Docket No.: 52-011

AR-07-0801

Southern Nuclear Operating Company  
Vogtle Early Site Permit Application  
Response to Requests for Additional Information Letter No. 6 Involving Geology/Seismology

**Response to March 15, 2007 RAI Letter No. 6**

RAI Figure 2.5.2-18A: Seismicity in southeastern US, showing earthquakes in the EPRI catalog (red dots) through 1984 and additional seismicity, 1985—mid April 2004 from the updated regional earthquake catalog.

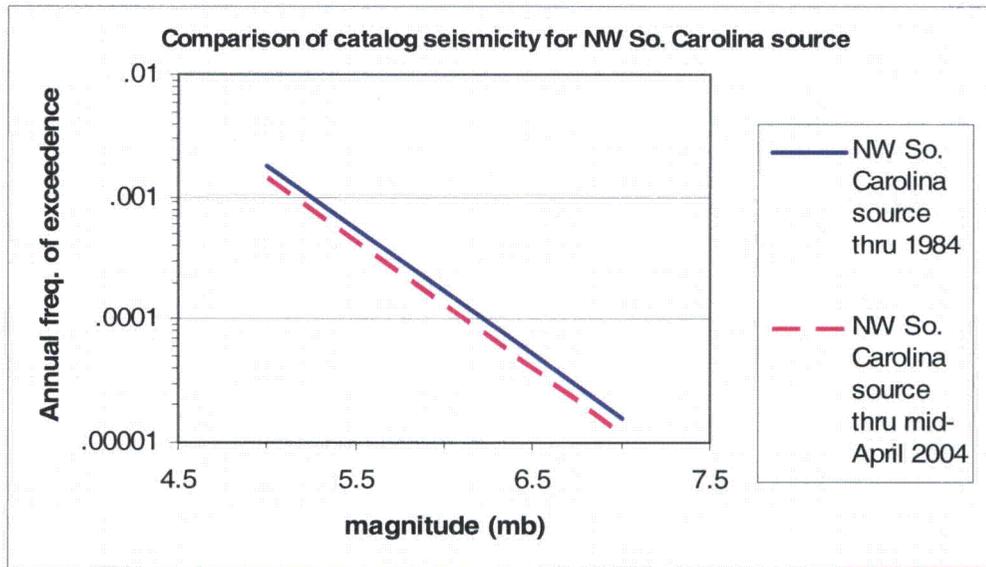
**2.5.2-18** SSAR Section 2.5.2.4.2 describes the effects of the new regional earthquake catalog. Figure 2.5.2-16 shows the two areas used to examine the effect of the new seismicity information. Please provide a justification for the geometries of the two areas.

Several areas were used to examine the effect of the new regional earthquake catalog. RAI Figure 2.5.2-18A shows those regions. All four regions showed the same result, that additional seismicity from 1985 to mid-2004 does not increase estimated activity rate in the area around the Vogtle site. As an example, RAI Figure 2.5.2-18B shows the effect of additional seismicity in the square, northwest-South Carolina source shown in RAI Figure 2.5.2-18A. The estimated activity rate decreases, similar to what is shown in SSAR Figure 2.5.2-18. We conclude that any region in South Carolina that would affect the seismic hazard of Vogtle would have estimated activity rates stay constant or decrease, if the new regional earthquake catalog were added to the analysis.

RAI Figure 2.5.2-21a Comparison between high-frequency spectral shapes using the recommended magnitude and distance values and the computed magnitude and distance values for the three annual probability levels of  $1 \times 10^{-4}$ ,  $1 \times 10^{-5}$ , and  $1 \times 10^{-6}$ .

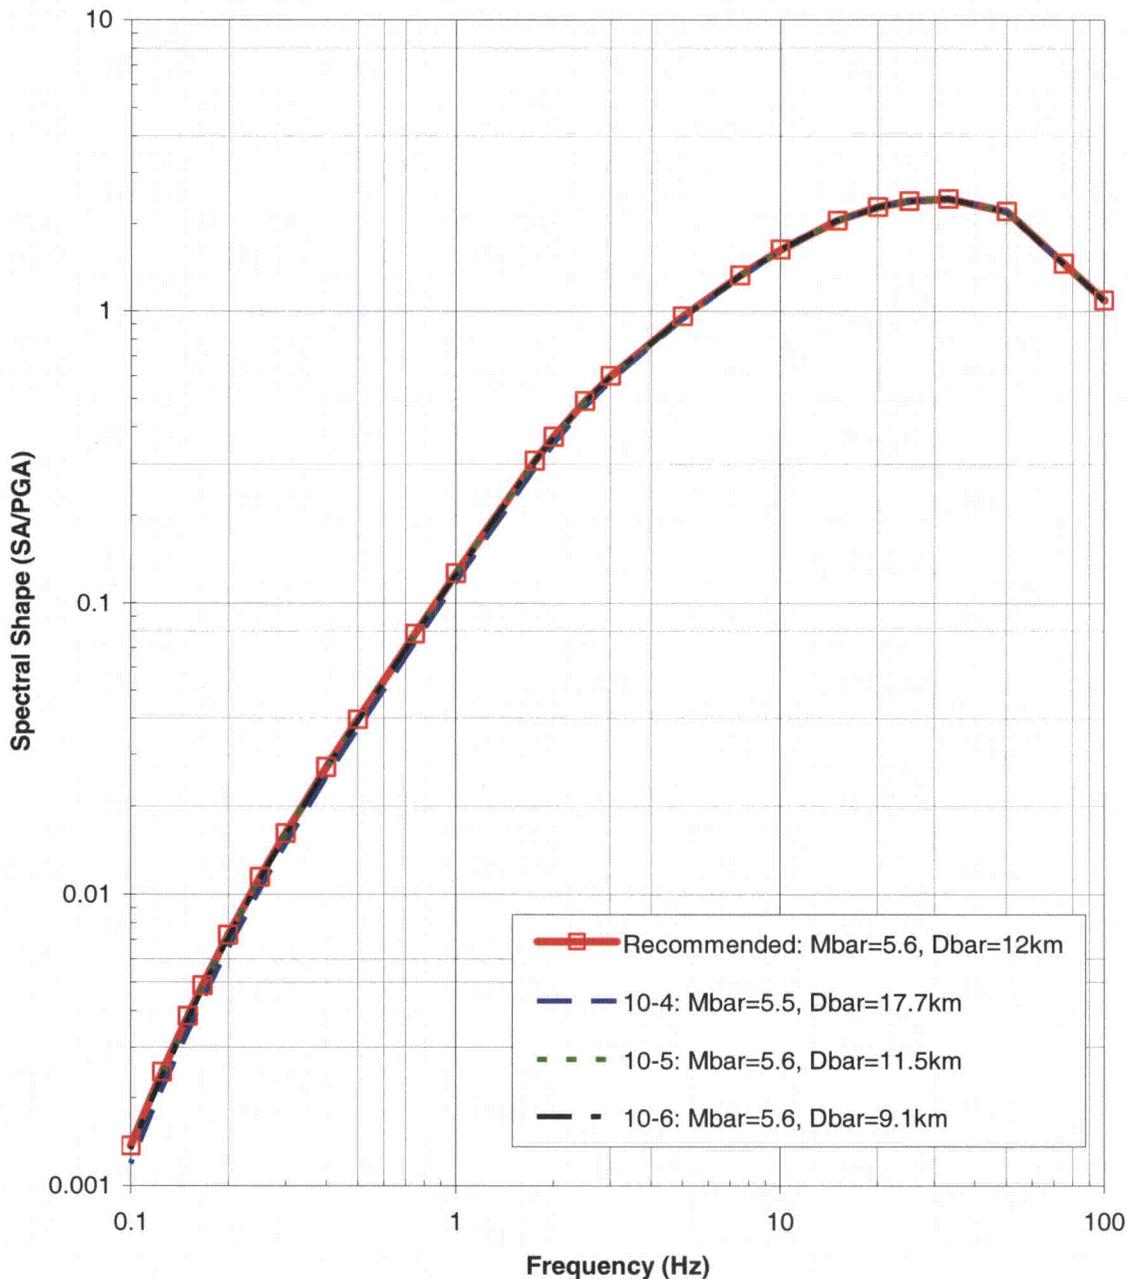
**2.5.2-21 SSAR Table 2.5.2-17 and Section 2.5.2.5.1.3 provides the computed and recommended Mbar and Dbar values used for the development of the high- and low-frequency target response spectra. Please explain how the “recommended” Dbar and Mbar values were calculated.**

Mean magnitude (Mbar) and distance (Dbar) values were computed for three annual probability levels:  $1 \times 10^{-4}$ ,  $1 \times 10^{-5}$ , and  $1 \times 10^{-6}$  based on the seismic hazard curves for both the high- and low-frequency cases. Table 2.5.2-17 of the SSAR lists these values along with the recommended magnitude and distance values used in the analysis. These recommended values were selected such that they approximately represent the range in Mbar and Dbar values computed for the three annual probability levels for both the high- and low-frequency cases based on the bi-modal distribution of the deaggregation. These recommended values were not computed based on a statistical average or otherwise from the explicit values for each of the three annual probability levels. For the low frequency case, the recommended distance value was assigned of distance of 130 km based on the source to site distance for the Charleston source. For the high frequency case, the recommended distance is approximately equal to the log-average of the three computed values rounded to the nearest km. The recommended magnitude values for both the high- and low-frequency cases is equal to the linear average of the three magnitude values rounded to the nearest tenth of a magnitude unit.

These recommended Mbar and Dbar values were used to simplify the analysis, rather than the computed values at the three annual probability levels, for the development of the corresponding target spectra and to a lesser extent in the time history selection procedure for the site response analysis. RAI Figure 2.5.2-21a shows the difference in spectral shapes for the high-frequency case using the recommended magnitude and distance values and the computed magnitude and distance values for the three annual probability levels. The same comparison is presented in RAI Figure 2.5.21b for the low-frequency case. Based on these comparison plots, the use of the recommended magnitude and distance values in place of the computed magnitude and distance values for each of the three annual probability levels would not significantly change the results of the site response analysis.

RAI Figure 2.5.2-23A. ESP Base Profiles – 5% Damping ARS Amplifications at 86 ft Depth

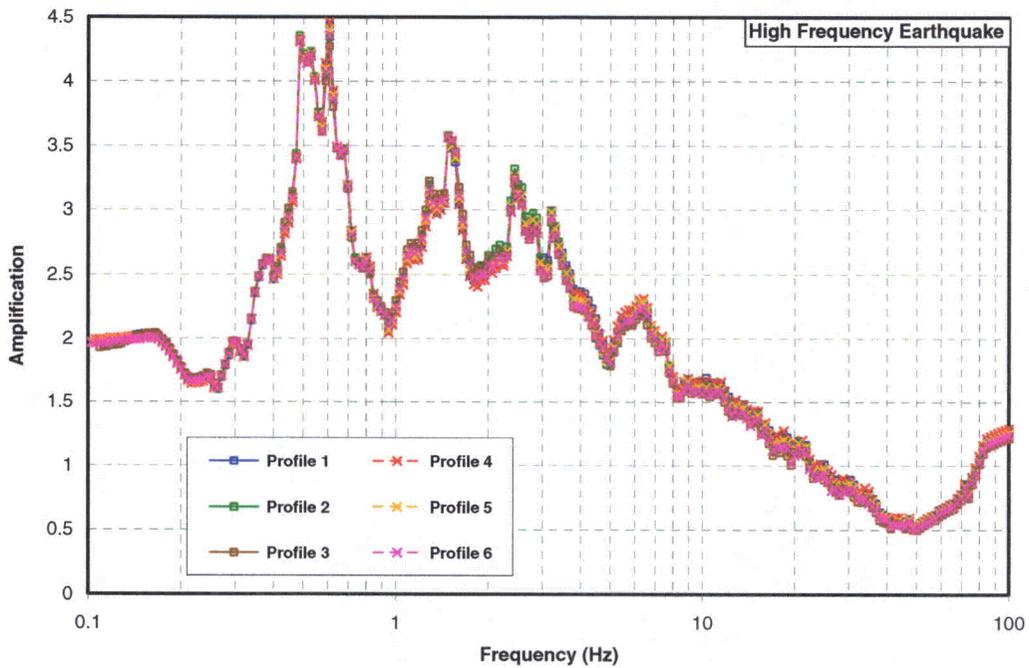
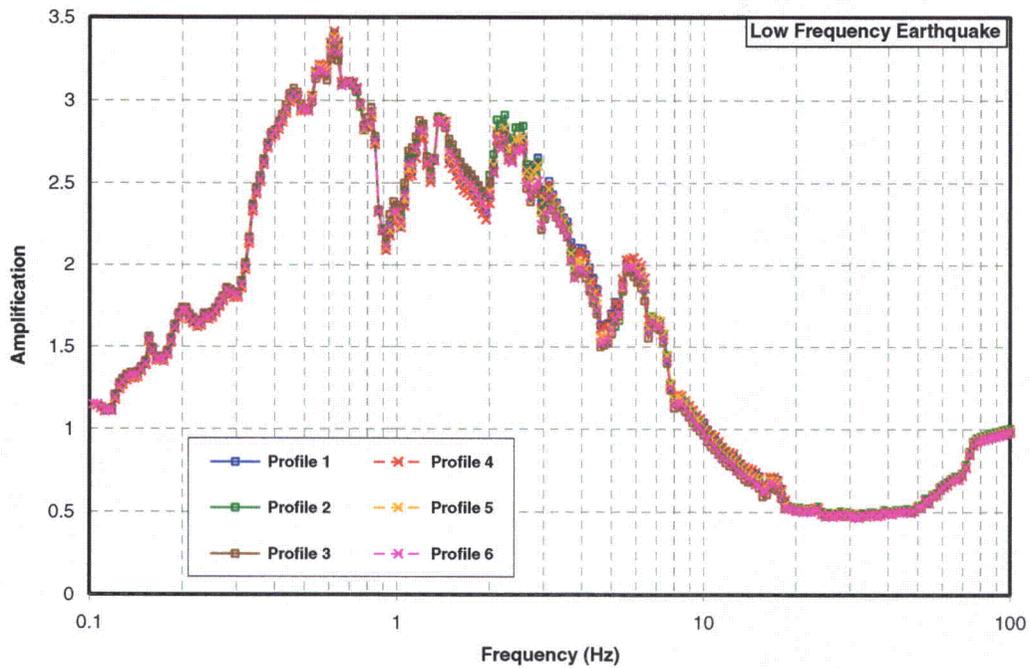
**In addition, please justify the adequacy of using an equivalent-linear approach rather than a nonlinear approach to model site response at the ESP site.**

The site response analyses of the ESP site used six base profiles to represent the properties of the rock strata located below depth of 1049 ft. RAI Table 2.5.2-23A below presents the rock shear velocity profiles:

Two acceleration time histories were developed compatible with the high frequency (HF) (5-10 Hz) and low frequency (LF) (1-2.5Hz) target spectra at  $1 \times 10^{-5}$  probability level. SHAKE analyses were performed where the acceleration time histories were applied as outcrop object motion at the top of the crystalline bedrock. RAI Figure 2.5.2-23A compares the results of the SHAKE analyses of the six base profiles for the 5% damping acceleration response spectra (ARS) amplifications at the top of the Blue Marl at 86 ft depth. The small difference in the ARS amplifications indicate that the effect of the depth of the crystalline rock on the site response at 86 ft depth horizon where the SSE design motion is defined is relatively small, particularly in comparison to the variability of total [soil and rock] site response when soil/rock column model randomization and multiple time histories are considered (see SSAR Figure 2.5.2-37).
